ADDENDUM NO. 06 TO THE BID DOCUMENTS

Bid Number: 2020-17-81
Utility Facility Improvements Project
Addendum Date: August 4, 2020

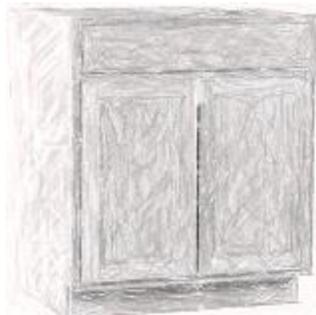
There is a confusion on what is just a countertop and what is a cabinet and also where the location of them are located? Will metal brackets work for the countertops or would wood be used? Cabinets where are they located and the microwave cabinet just a lower or is there an upper cabinet also? Please see the highlighted drawing attached for where we think the countertops and cabinets are being installed. The only cabinets that I see are the microwave cabinet and the one at the printer station. I only see cabinets in 1 of the 2 printer stations.

The sink cabinet—please see Addendum No. 4

The Microwave cabinet---use 30" wide base cabinet

Formica Laminate Sheet in Geriba Gray Laminate

“Exhibit D”

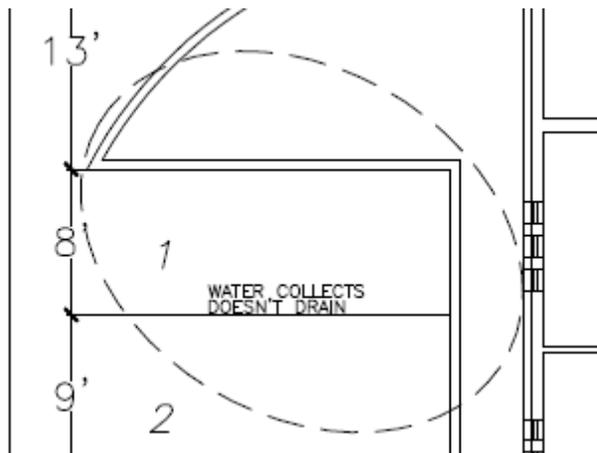
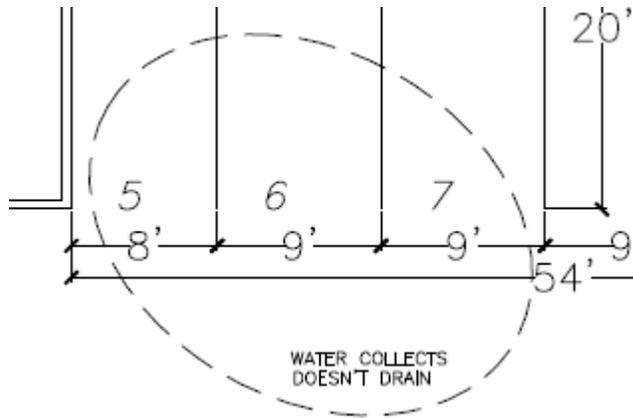
- On page 4 of the RFI's (addendum 1) number 10. They still didn't give any spec of what lights they want to use. Is this supposed to be a design build?

Please see attached "Exhibit D"-please use 2X4 LED

**BrightStar 2X4 LED Ready Troffer w/ 18 Cell Parabolic,
3 T8 LED Tube Requires BrightStar 55050**
